Procter & Gamble Cogeneration Project

**COPIES OF RESPONSES TO INFORMATION REQUESTED BY CEC STAFF FOR THE  
PROCTER AND GAMBLE COGENERATION PROJECT (DOCKET NO. 93-AFC-02)**

**RESPONSES TO CEC DATA REQUESTS  
(Set 1, dated December 3, 1993)**

SMUD Transmission System  
With No Project Generation  
Figure 3.15-7

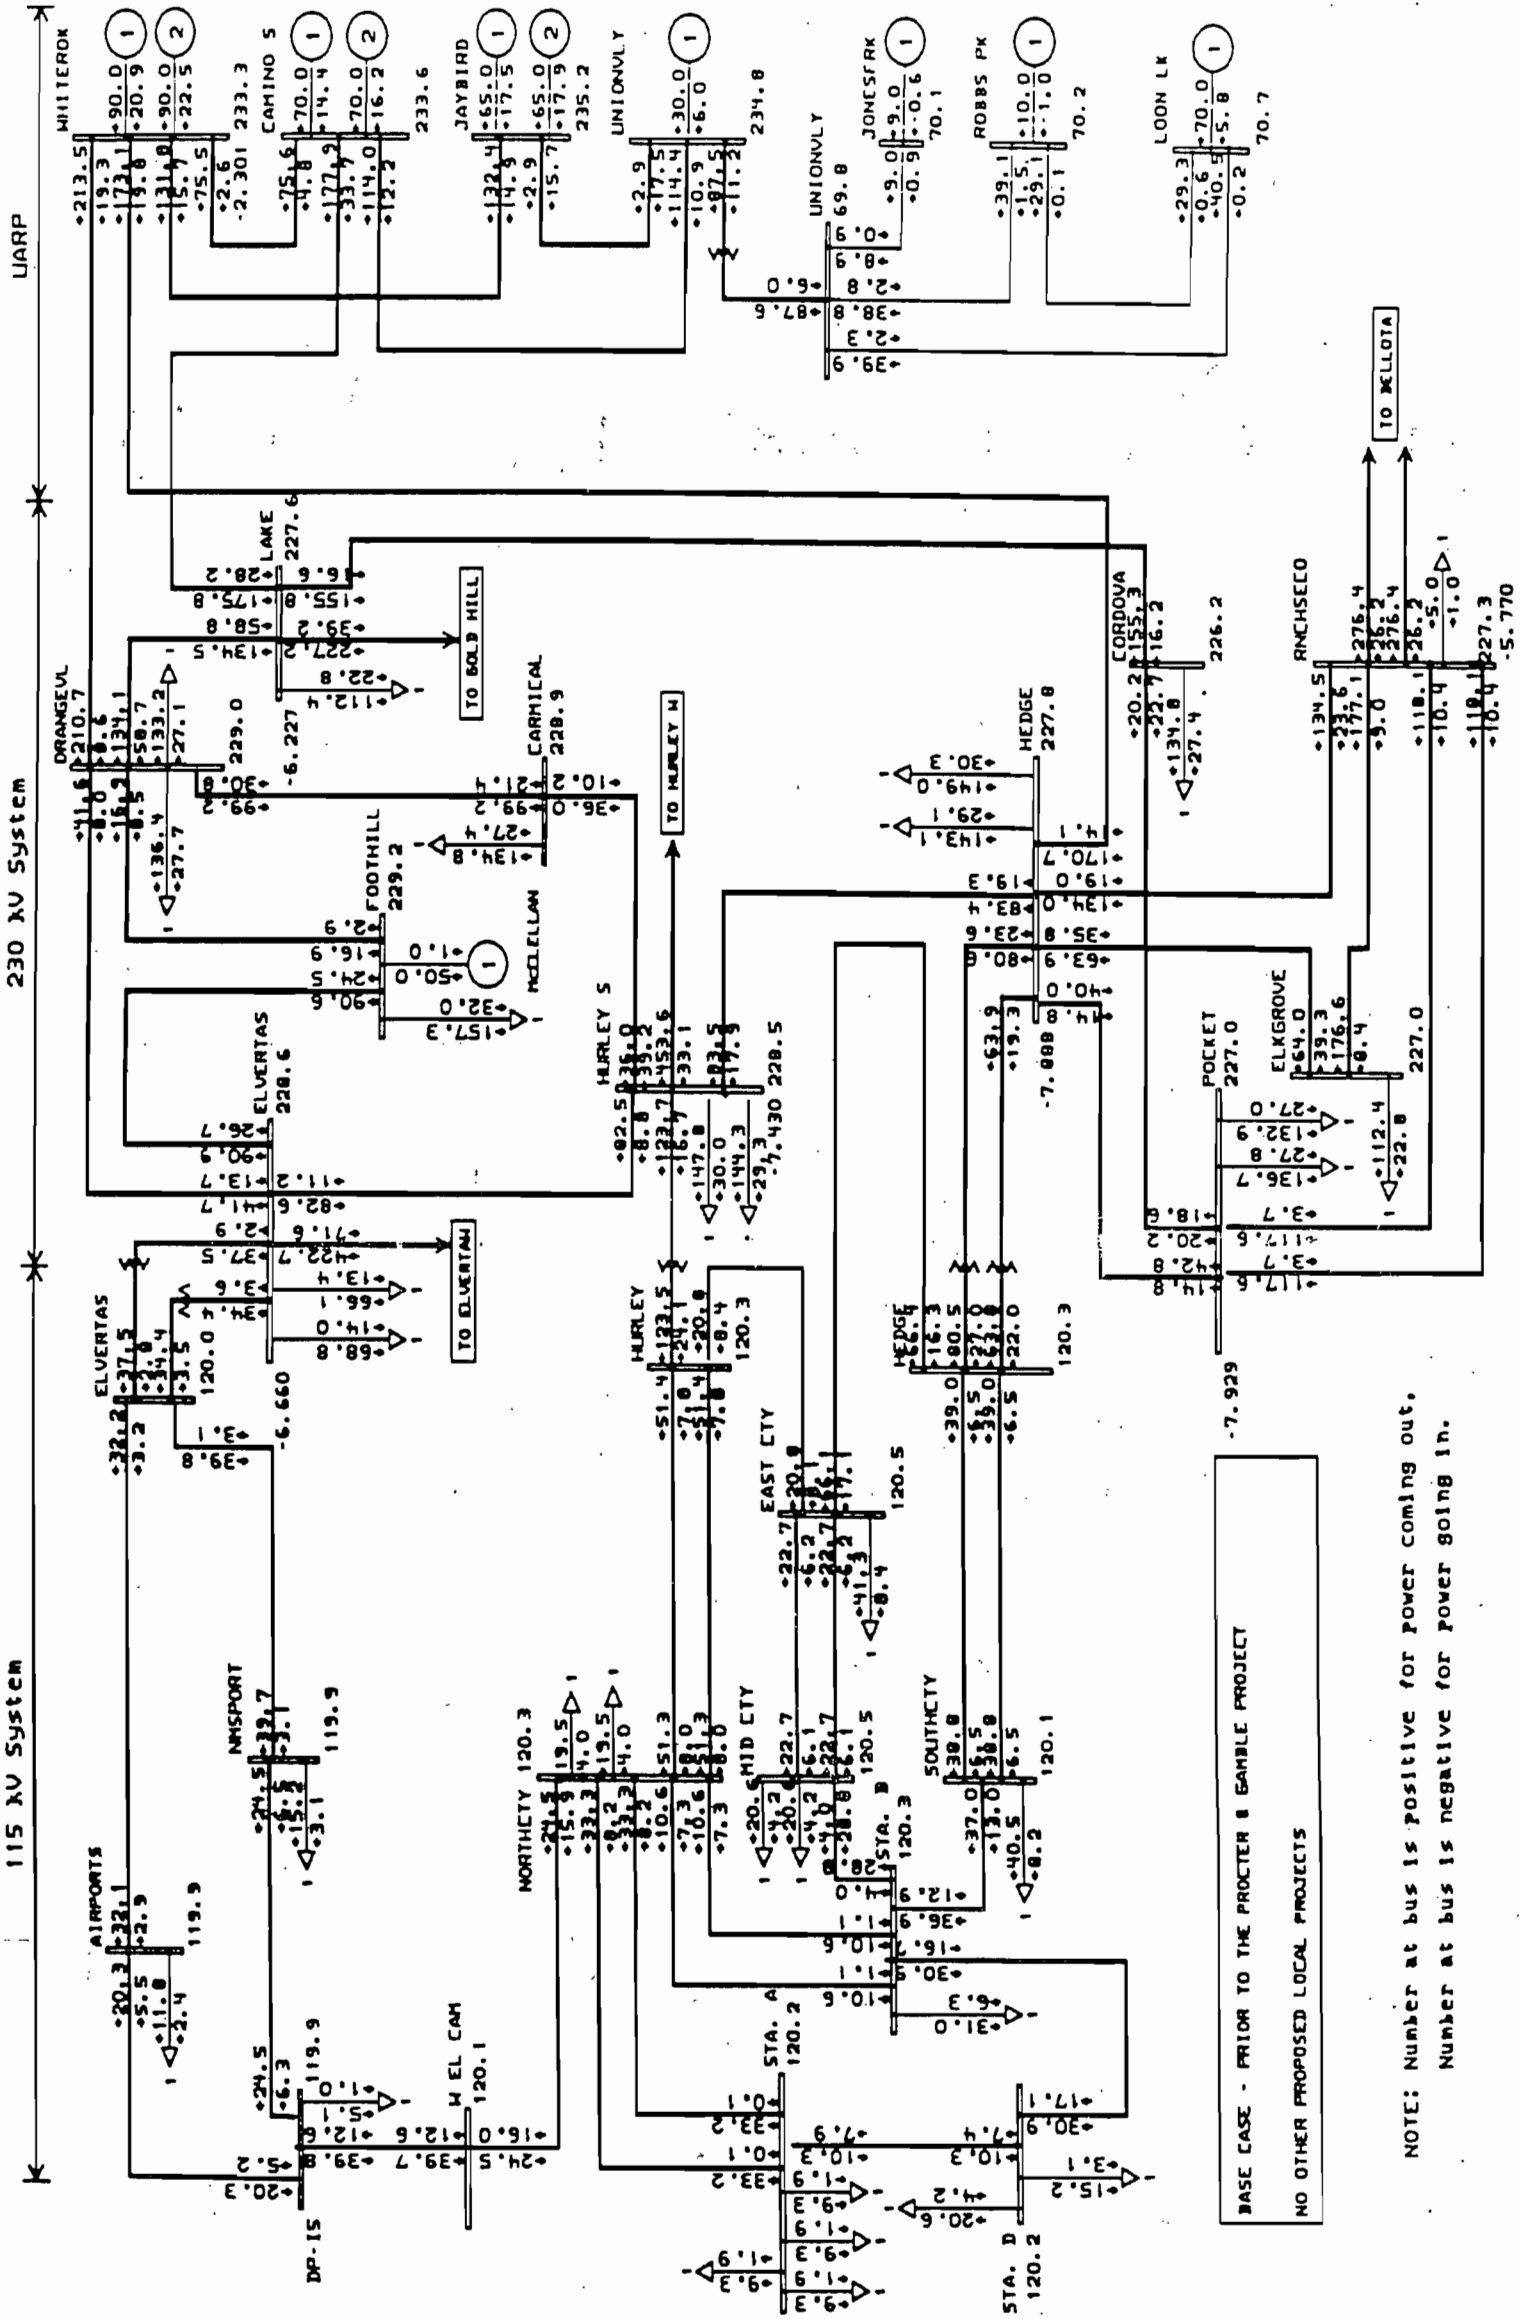
- legible copies of figures 3.15-7, 8, and 9;
- names and telephone numbers of agency personnel, identification of the source for Section 6's discussion of City areas experiencing renewal, and a clarification of what information figure 6.6-3 is intended to convey;
- numbering/citing of references within the transportation text, clarification of a discrepancy regarding traffic numbers on figure 6.5-4, and a discussion of actual traffic numbers and volume-to-capacity ratios in relation to LOS during construction;
- amended table 3.6-1 to include seismic design coefficients and typical plans, elevations, and sections for the cooling tower and elevated deaerator support structure. Please note that the elevator deaerator support structure will be designed as a building framed system in accordance with UBC Section 2.3.3.3 paragraph F.
